**2022 Final Environmental Impact  
Report**

Grayson Repowering Project

January 20, 2022

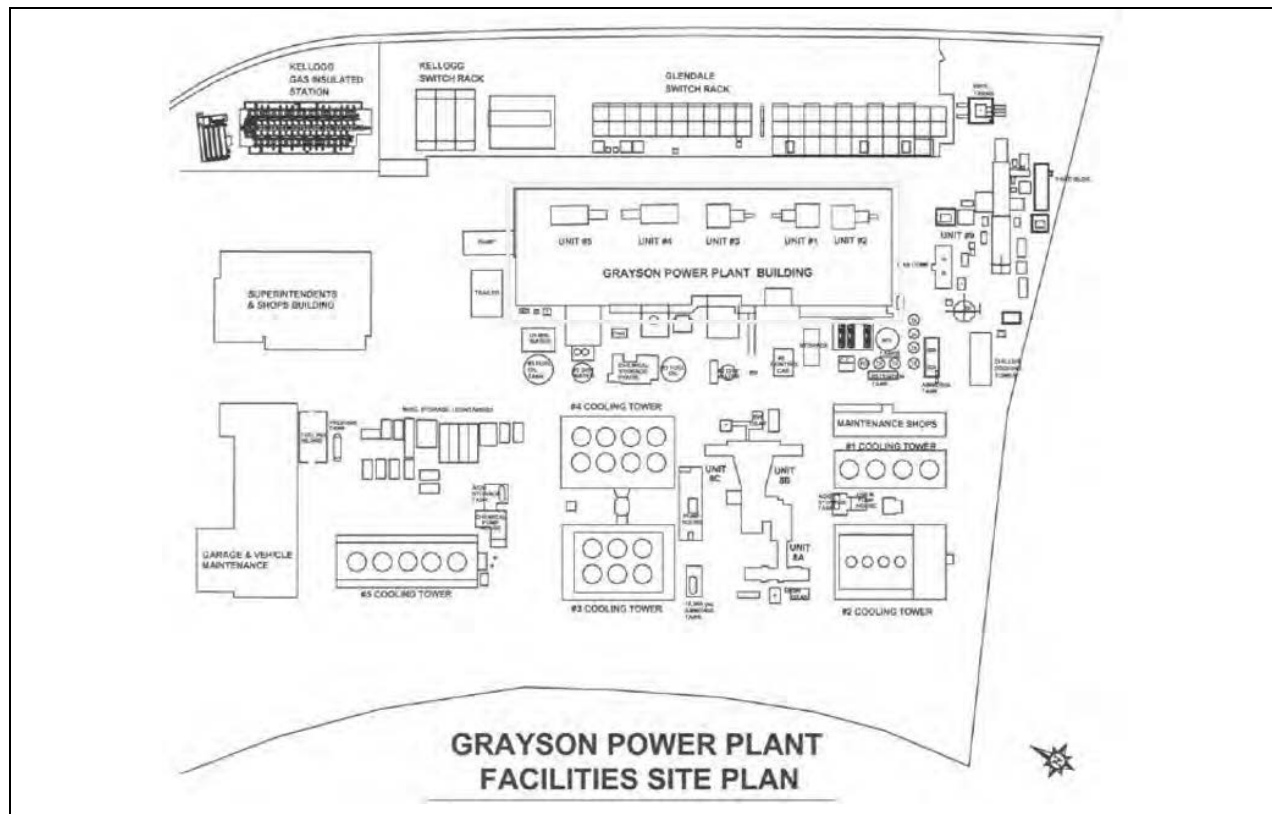
Figure 1 makes evident the fact that there are no alterations on the façade or northeast side, none are shown on the southeast end wall (a carport was added sometime after 1950 that does not affect its integrity), various small additions on the non-character-defining southwest side and only a ramp was added on the northwest side.<sup>1</sup> Further text will describe why other small changes do not affect its integrity. The building's principal cladding materials remain, its original ribbon, hopper-type and glass block multi-story windows remain, the original metal sign on stand-outs and the distinctive, staggered, horizontal corner fillets remain intact. An experienced architectural historian would have exercised appropriate professional judgment and omitted items that were not alterations that affected the actual resource under consideration. The Grayson Steam-Electric Power Plant structure retains more than adequate integrity to its original design by Daniel A. Elliott, AIA, and remains recognizable.

<sup>1</sup> An "addition to boiler room" at the southwest corner is noted in the Initial Study Figure 15 annotated aerial photographs incorrectly as being added around 1979 (Aerial 4). That small addition is clearly evident in Aerial 2, the 1964 aerial photograph.

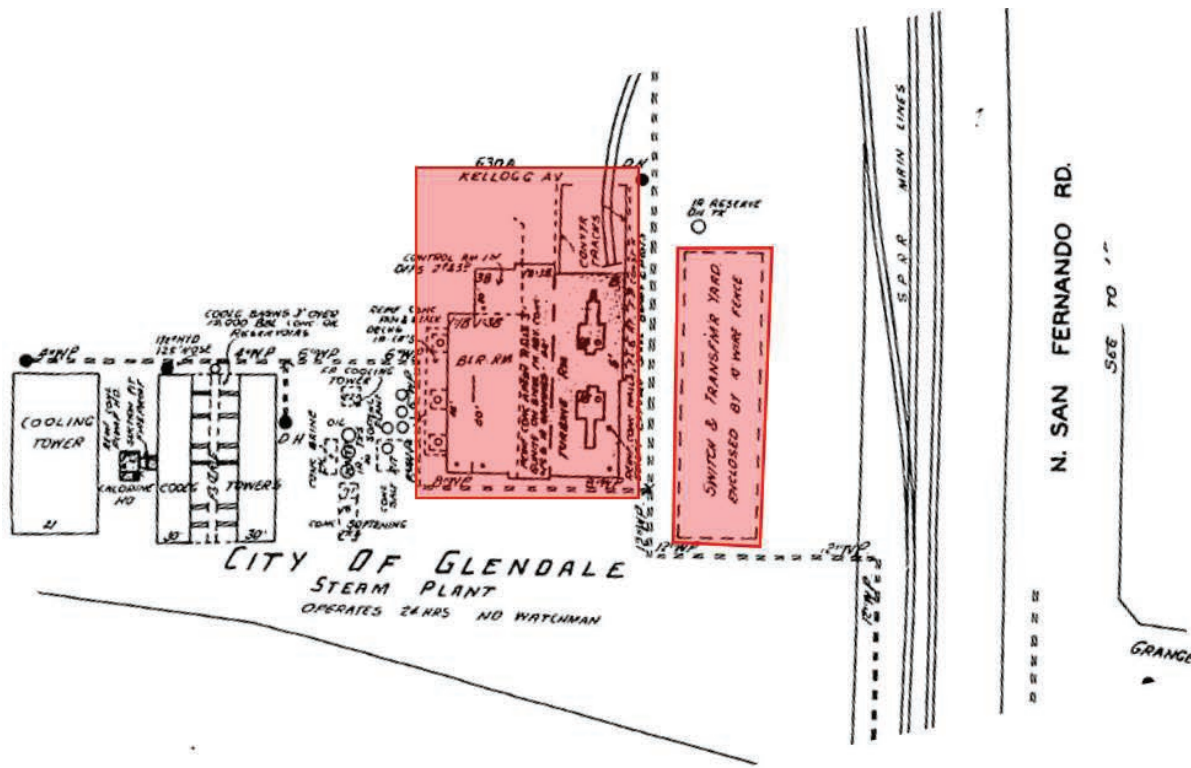
L22-9 ■ We note that the Glendale Switch Rack, which dates from the same year as the Boiler Building (1941) and was central to the property’s operation as a power plant should be considered historically significant as well (see Figure 1 on page 4). ↓

Figure 1, above depicts the Boiler Building and the functionally-related, and currently extant Glendale Switch Rack in 1950. Review of aerial photographs from the same time period reveal the same relationship between the Boiler Building and Glendale Switch Rack. If the property had been appropriately, impartially evaluated for historic significance impacts and effects we believe the Glendale Switch Rack and likely other part of the property would likely have been identified as contributing features of what may likely be a historic district.

Figure 3: Annual Greenhouse Gas Emissions

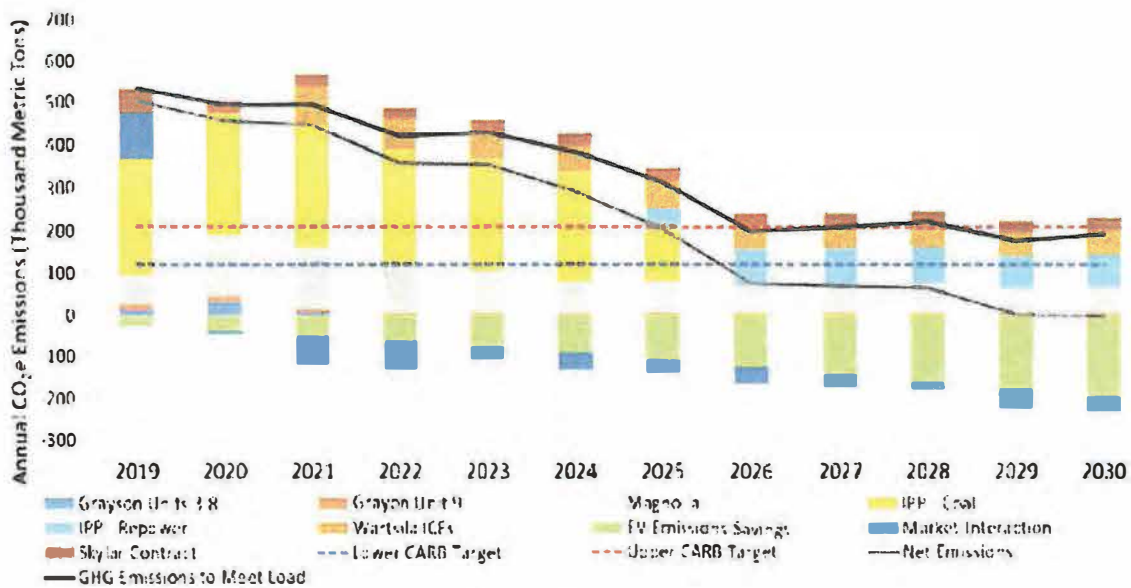
L24-7 The commenter stated "Figure 3 from the IRP shows GWP's projected GHG emissions from its fossil fuel energy production, both local and imported. Please

*The commenter further stated "A further misrepresentation in the figure is GWP's treatment of EV's and tailpipe emissions. Please observe the green bar in the 2030 section of figure 3. This segment represents 200,000 metric tons of GHG emissions which GWP mysteriously claims credit for avoiding. It is as if these EV's are driving around the City sucking up 200,000 metric tons of GHG per year and getting rid of them. The reality is quite the contrary. Not only do the EV's not remove GHG's, but tailpipe emissions are not a factor in the EIR evaluation of a new gas plant in Glendale. Furthermore, every MW hr of the energy these EV's use must be generated locally or imported, and our use of locally generated or imported fossil fuel based energy is increasing not decreasing."*

Figure 3 demonstrates the linkage between transportation sector and the electric sector. The figure and narrative clearly state that in the future electric vehicles will take trips that were previously taken by gasoline vehicles. These vehicles run on clean electricity provided by GWP. This represents a GHG reduction in the transportation sector that would not be possible but for the clean electricity provided by GWP. Even in the case of an EV owner having solar panels, most at home charging occurs at night when GWP is providing power. Tailpipe emissions are relevant as the vast majority of criteria air pollutants as well as GHGs in the LA basin come from vehicles. As the 93 MW of reciprocating engines are an integral part of a reliable Glendale power system, they help enable a region-wide conversion of vehicles as well as indoor air and water heating to electricity, and thus it has a direct impact on improving air quality in the region.
